# Integrated Dryland Ecosystem Rehabilitation, Regeneration and Conservation (IDERRCN) to Support the Great Green Wall Initiative in Kebbi State in Nigeria.

Review CEO Endorsement and Make a recommendation

**GEF ID**  
11461  
**Countries**  
Nigeria  
**Project Name**  
Integrated Dryland Ecosystem Rehabilitation, Regeneration and Conservation (IDERRCN) to Support the Great Green Wall Initiative in Kebbi State in Nigeria.  
**Agencies**  
UNEP  
**Date received by PM**  
6/20/2025  
**Review completed by PM**  
12/3/2025  
**Program Manager**  
Jean-Marc Sinnassamy

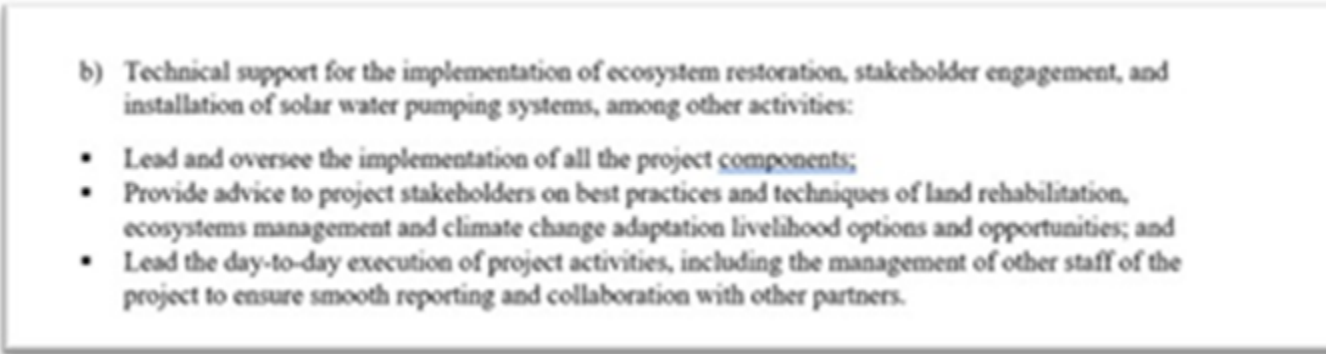
- MTR and TE should be categorized as consultants instead of Training/workshop/meetings. Please revise the budget accordingly.
- Works item to cover seedlings, agroforestry inputs, materials, tools, etc?. should be categorized as Goods (equipment, materials, supplies) while the works item to cover

workshops, consultations, meetings, etc.) should be categorized as Training/workshop/meetings. Please revise the budget accordingly.

Response: As guided, MTR and TE have been categorized as consultants, and the budget has been revised accordingly.
